Service BULLETIN

Reference: MFSBA-2501 Rev 00

Alert Service Bulletin - Kit for STC SA011869WI

Figure 1: Affected Area

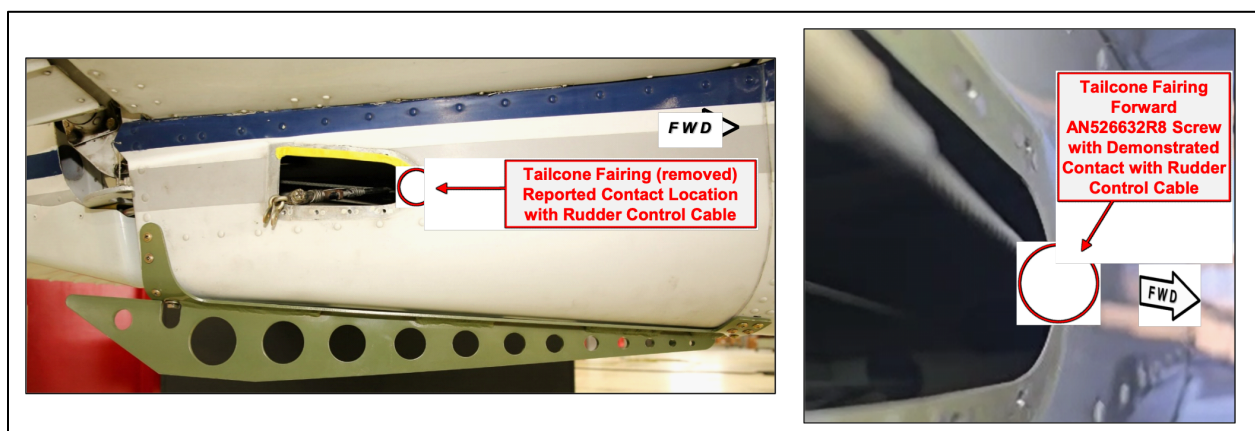
There is a potential safety issue regarding the installation of the Tail Tie-Down Assembly interference with the rudder control cable. Two incidents have been reported in which the installation of this modification results in the rudder control cable contacting a fairing screw installed by this Kit. This condition could result in severance or fraying of the cables with loss of rudder control. Figure 1 identifies the area in question.

Tail cone fairing fasteners are to be inspected for damage and wear and replaced if such is found. Rudder control cable assemblies shall be inspected for separation, broken wires, fraying of cables and wear. Inspect the rudder flight control cable installation to see if any damage or changes exist outside the modifications introduced by this Kit that would change the location of the rudder control cable.

Worn or damaged rudder control cables shall be replaced. There shall be positive clearance between any item on the aircraft and the rudder control cable.

Figure 3: Removed Fairing with Reinstalled Screw for Clearance Inspection

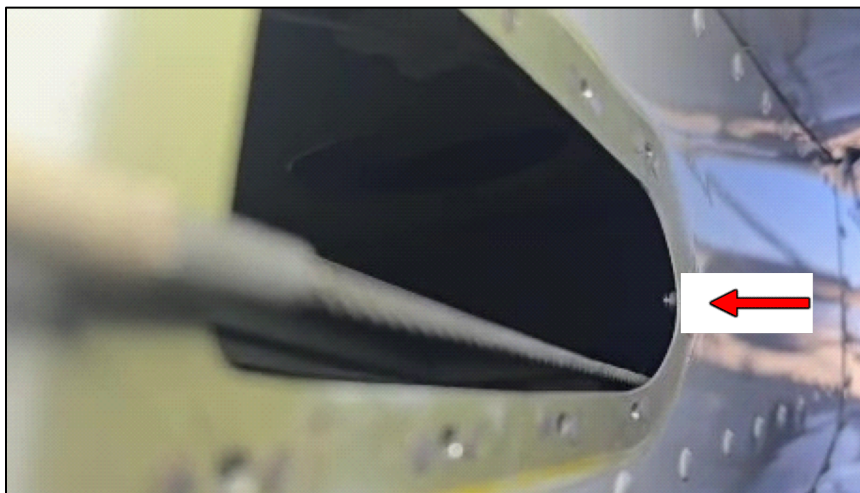
- 3) Inspect rudder cable in the vicinity of the Tail Tie Down Assembly 16-020-534530.
 - (a) If no wear or damage is observed on the rudder control cable at the location of the Kit screws and nutplates, no further action is required regarding the rudder control cable.
 - (b) If any wear or damage is observed on the rudder control cable at the location of the Kit screws and nutplates, replace the rudder control cable following approved guidance of the applicable Textron/Cessna AMM or FAA AC 43.13-1B.
- 4) Leaving fairing uninstalled thread AN526632R8 screws back into MS21069L06 nutplates to the same depth they would protrude through the inside of the fuselage with the fairing installed.

- 7) While rudder cable is being moved due to rudder travel, ensure that at any point in its motion there **positive clearance** (i.e. no contact) between the rudder control cable and the fairing AN526632R8 screw or MS21069L06 nutplate.

- (b) If at any point in the full rudder motion, **positive clearance is not maintained** (i.e the contact) between rudder control cable and AN526632R8 screw or MS21069L06 nutplate, then the aircraft must be grounded until a Service Bulletin is issued to correct the potential safety issue.
